COUNTY OF VENTURA PUBLIC WORKS AGENCY WATERSHED PROTECTION DISTRICT ZONE 2 "J" STREET DRAIN IMPROVEMENT ORMOND BEACH LAGOON TO DOWNSTREAM OF HUENEME ROAD IN THE CITY OF OXNARD

SAVE DATE: 5/21/13 DOKTORN K:\PC\PROJECTS\82322 J STREET DRAIN IMPROVEMENT\FINAL DESIGN\DESIGN DRAWINGS\100%ADDENDA\ADDENDUM NO. 1\JSD-01-GP.DWG

"J" STREET DRAIN IMPROVEMENT
ORMOND BEACH LAGOON TO
DOWNSTREAM OF HUENEME ROAD
GENERAL PLAN

SHEET 6
OF 31
DRAWING NO.
Y-2-3710

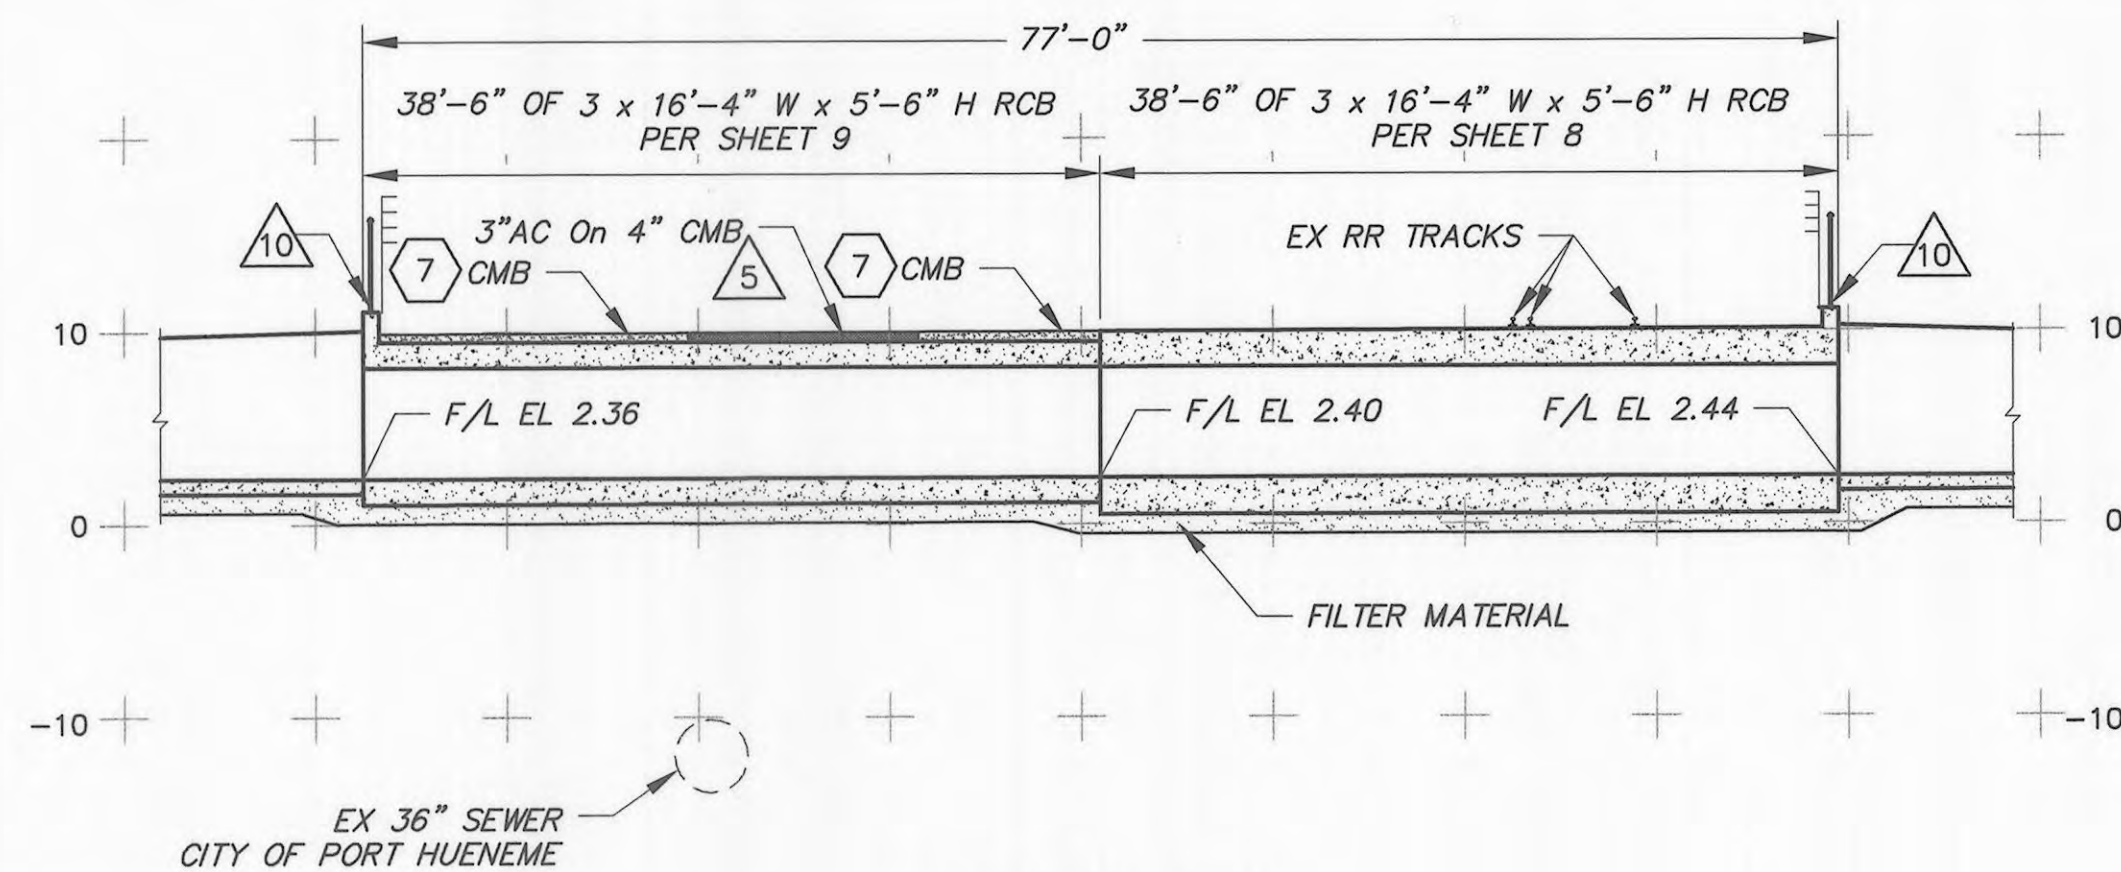
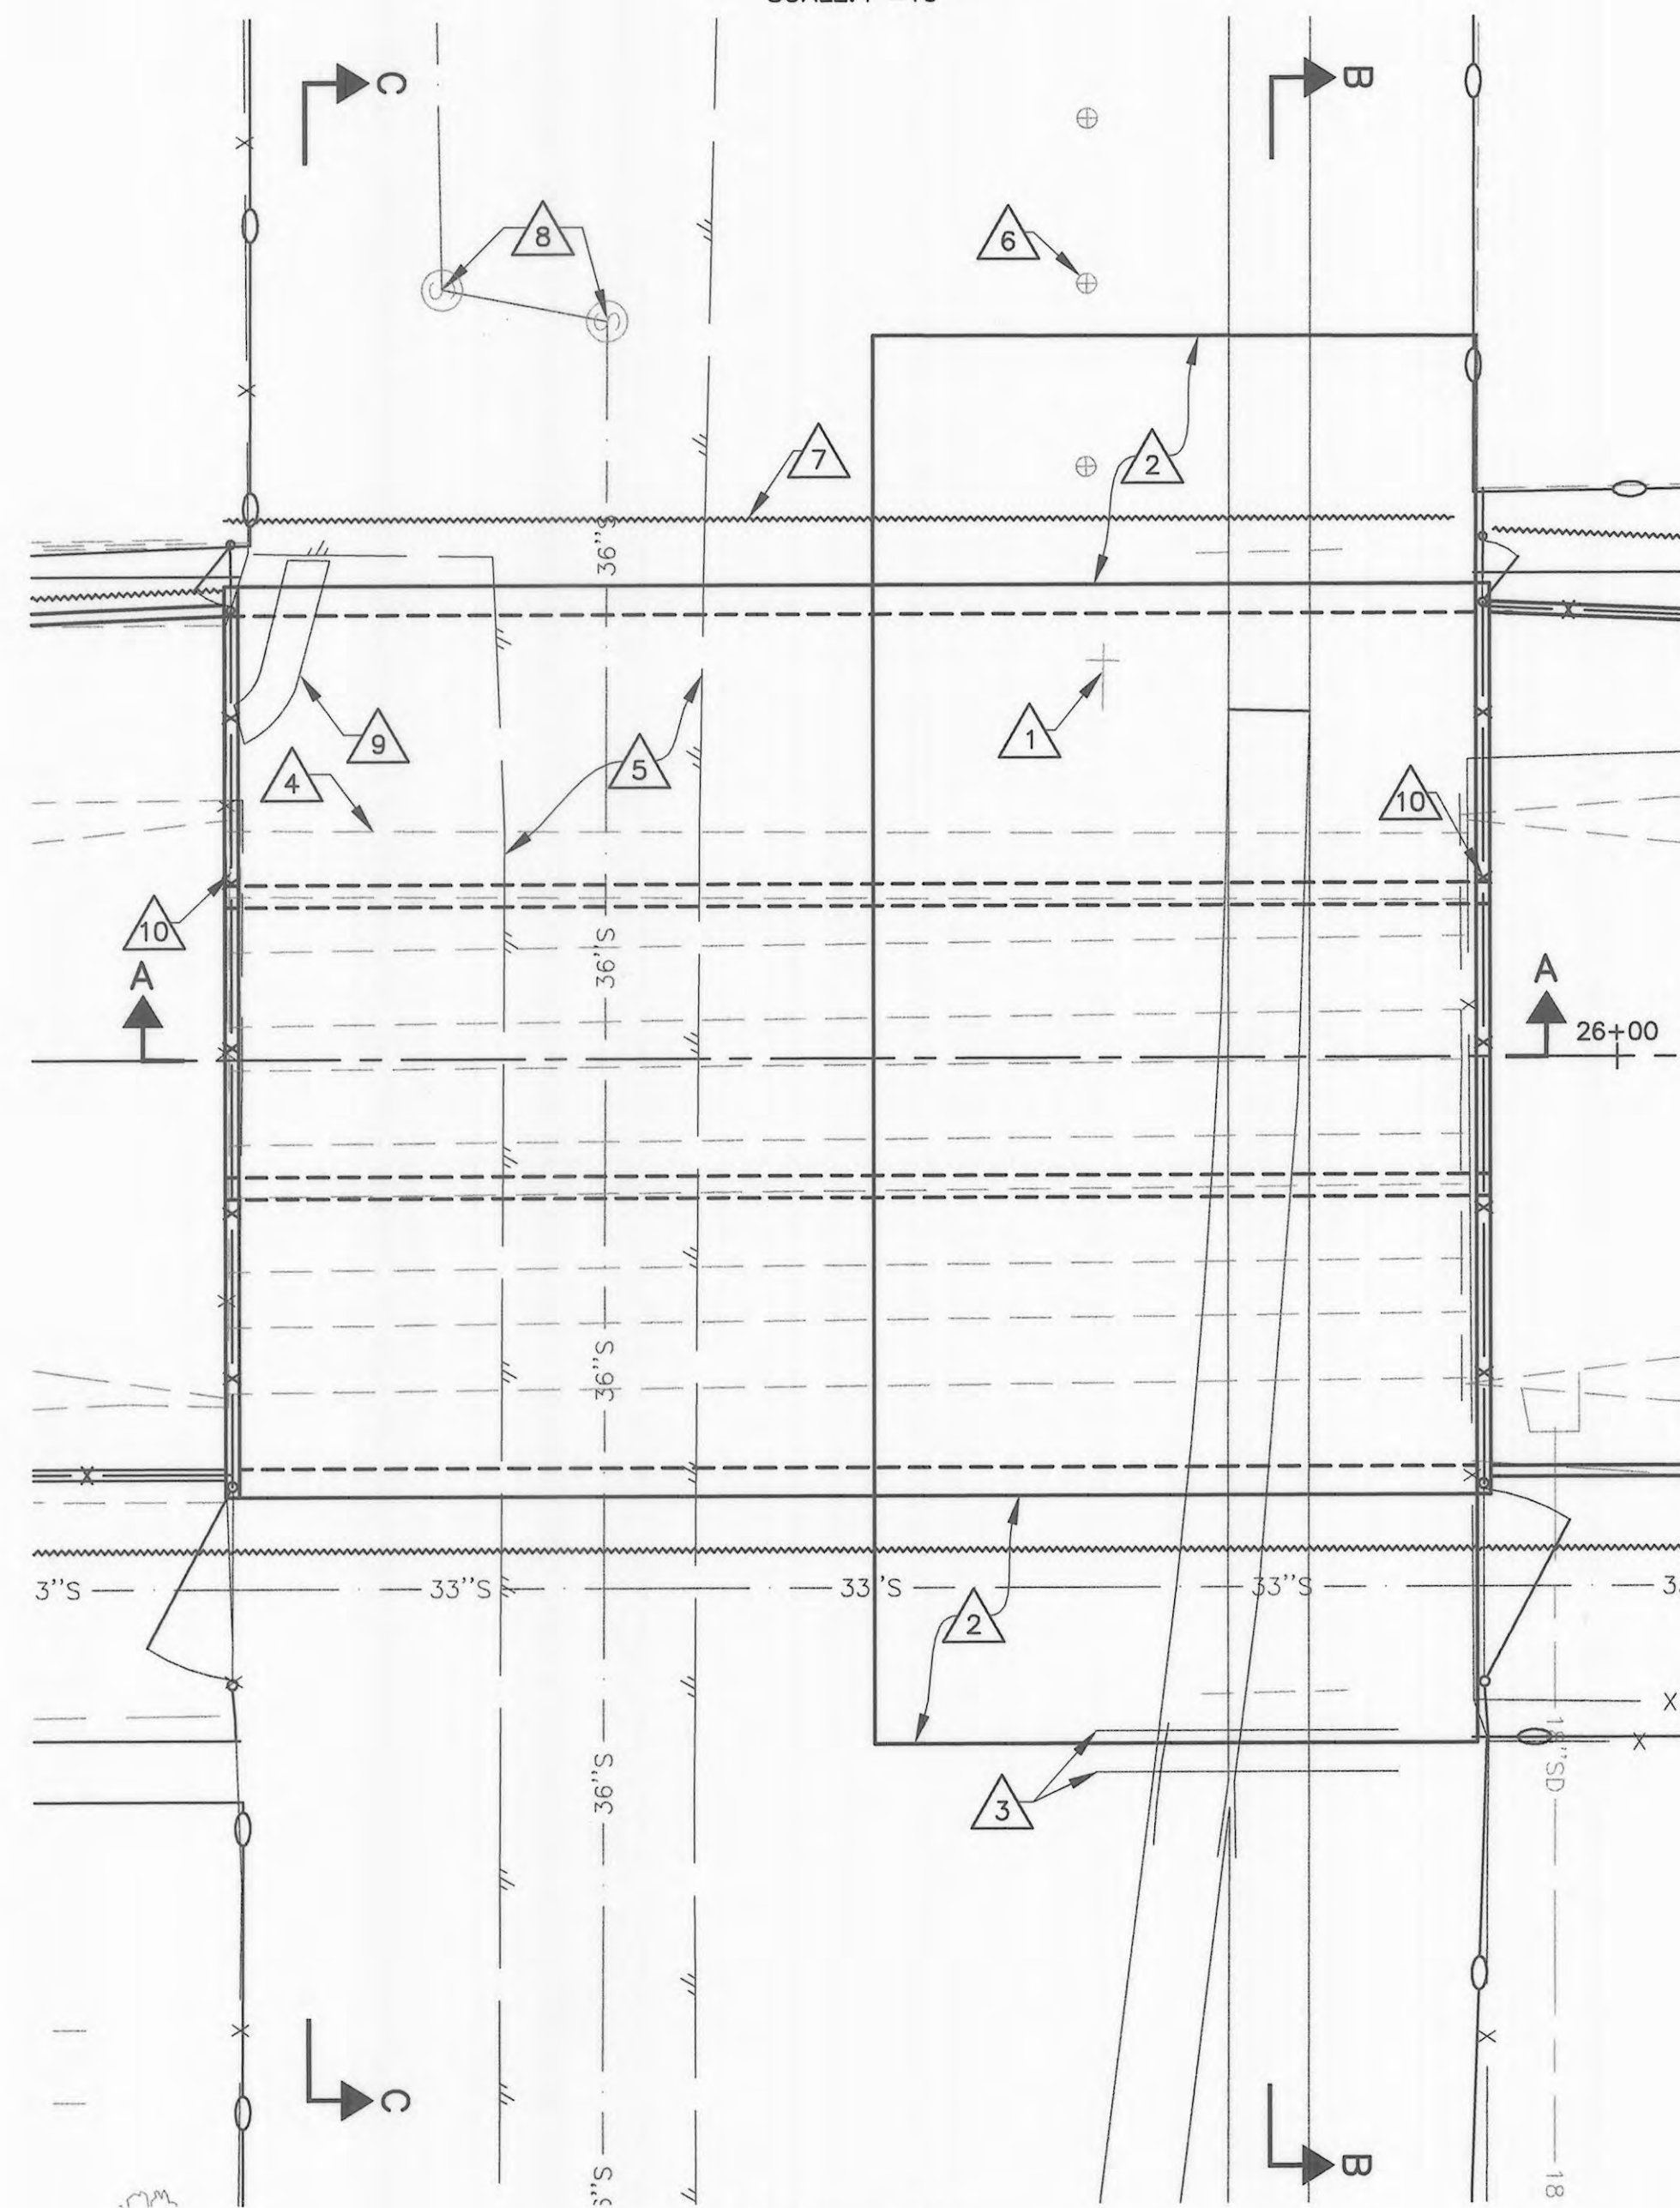
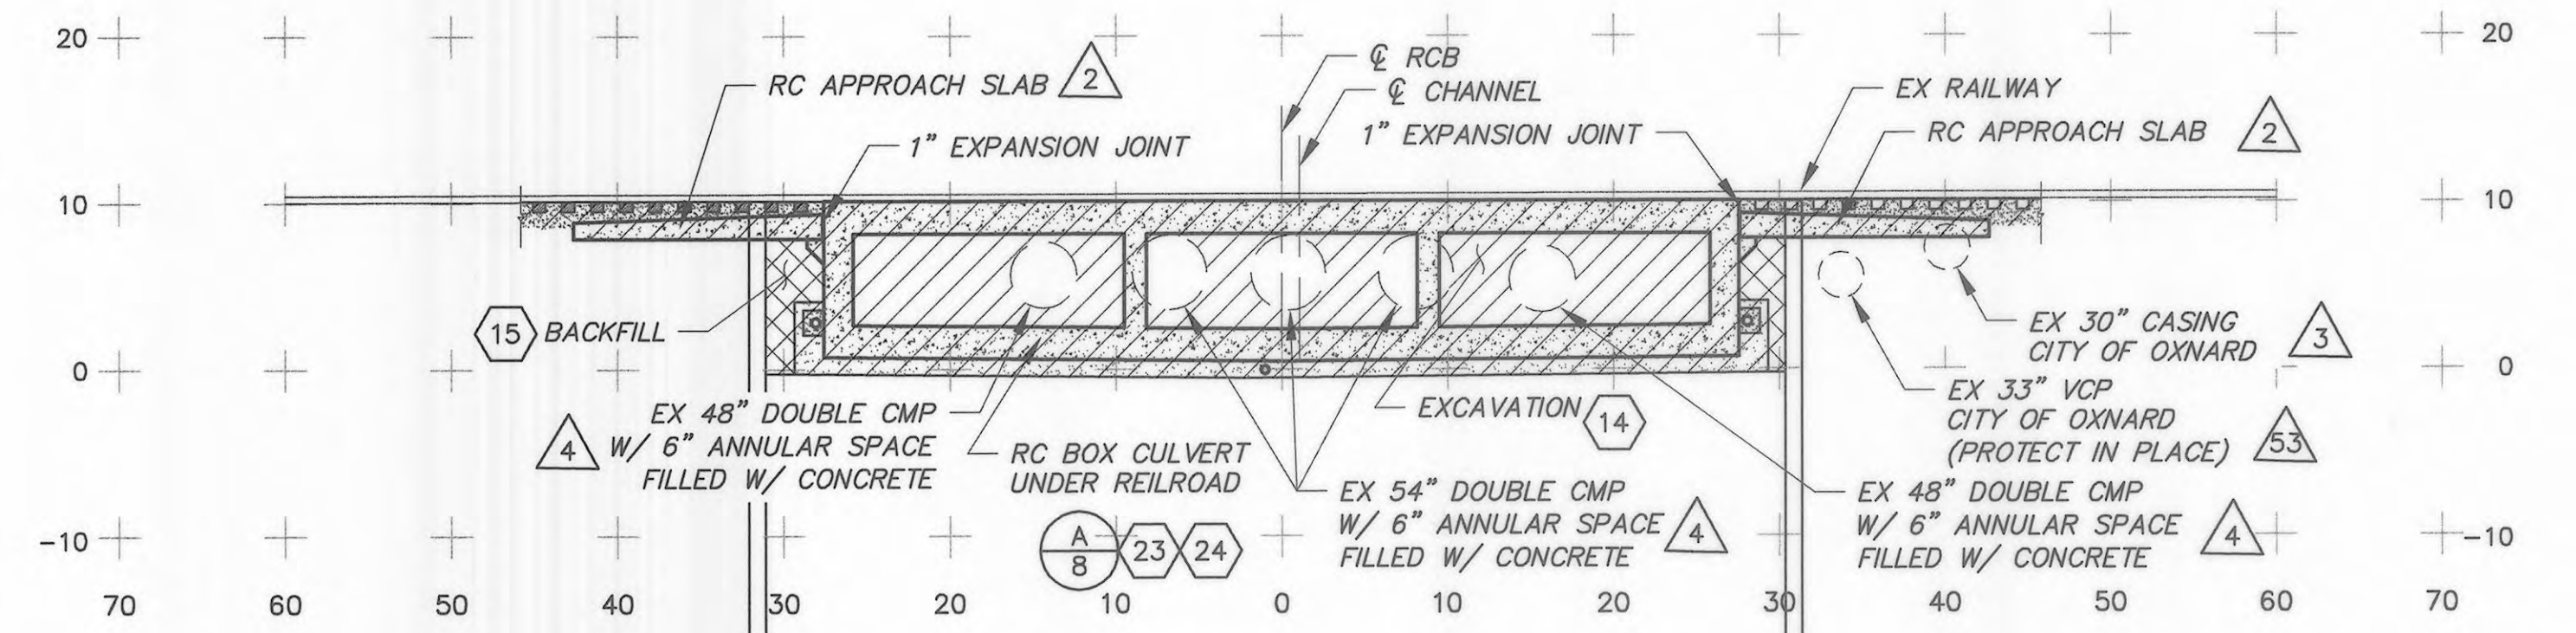
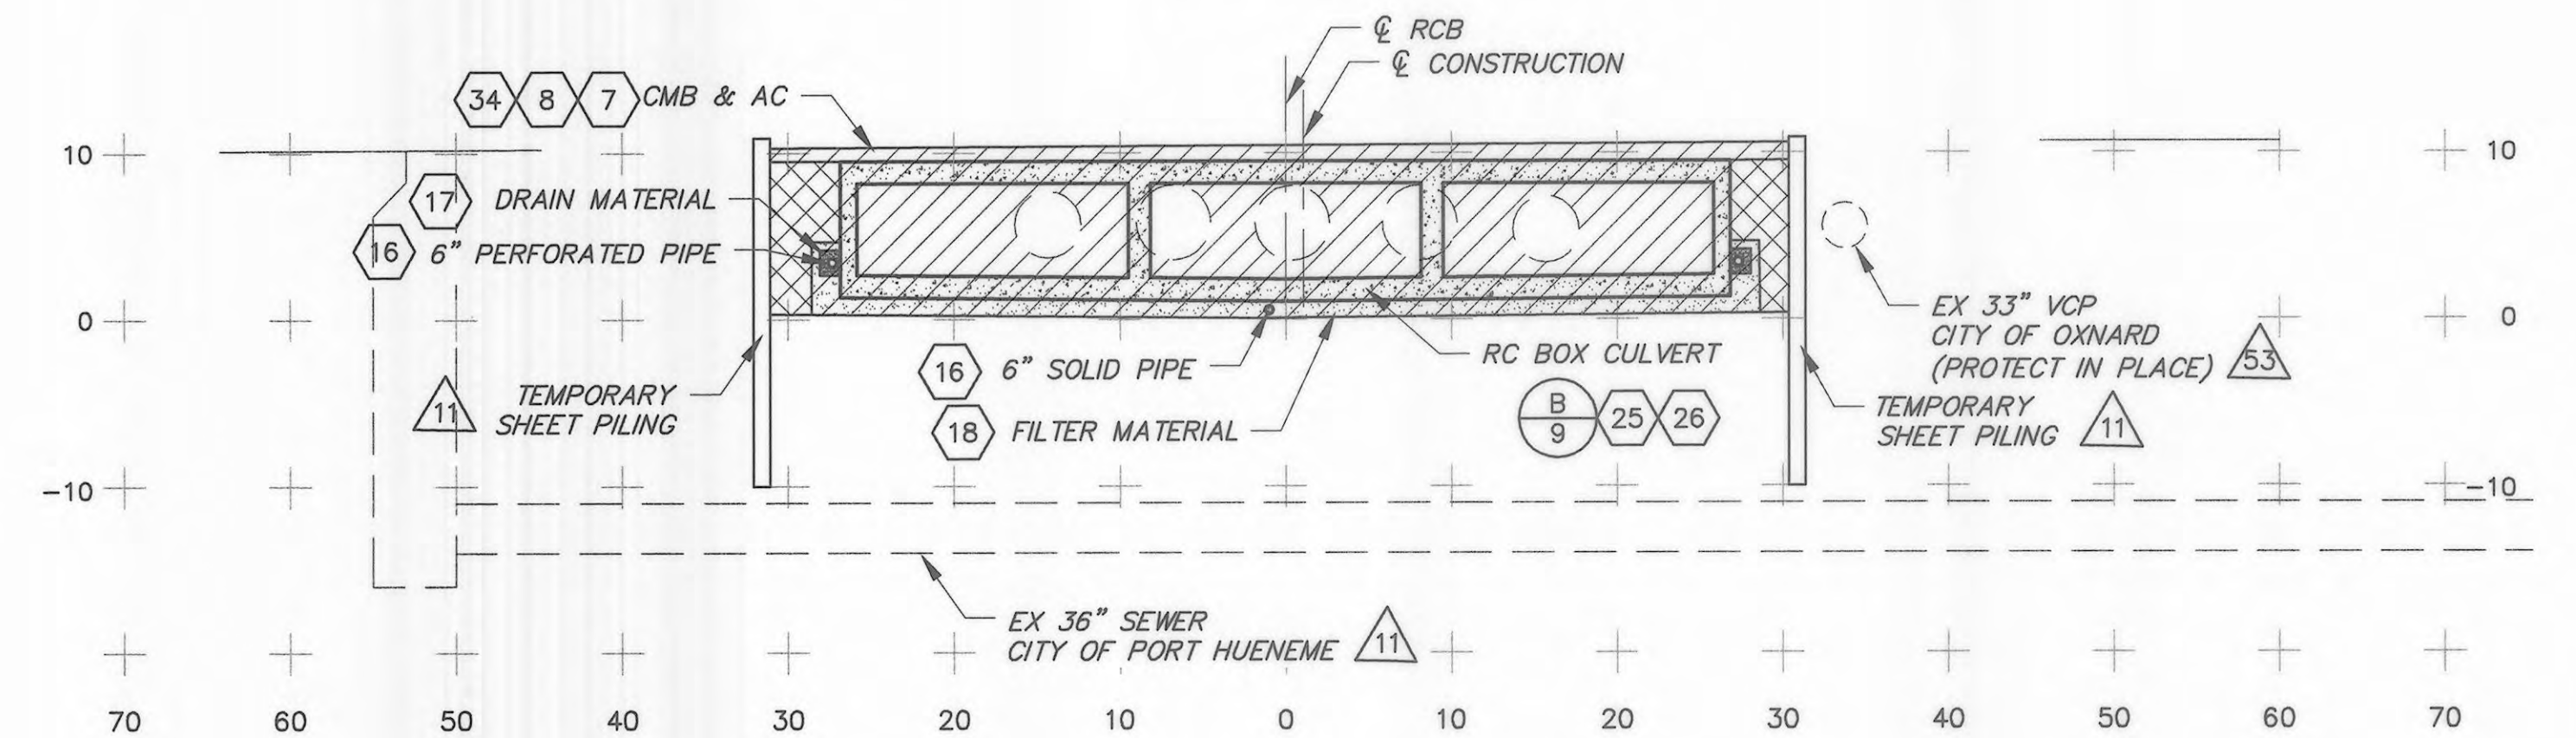
DESIGNED K. ROUSSEV 5-20-13	PROJECT MANAGER Kirk Norman (acting) 5-20-13	DATE 5-20-13
DRAWN K. NORMAN 5-20-13	CHECKED J. R. NORMAN 5-20-13	DATE 5-20-13
RECOMMENDED AECOM DATE	APPROVED PORT OF HUENEME, OXNARD HARBOR DISTRICT DATE	
REVISION A REVISED RC APPROACH SLAB	DESCRIPTION APP. DATE
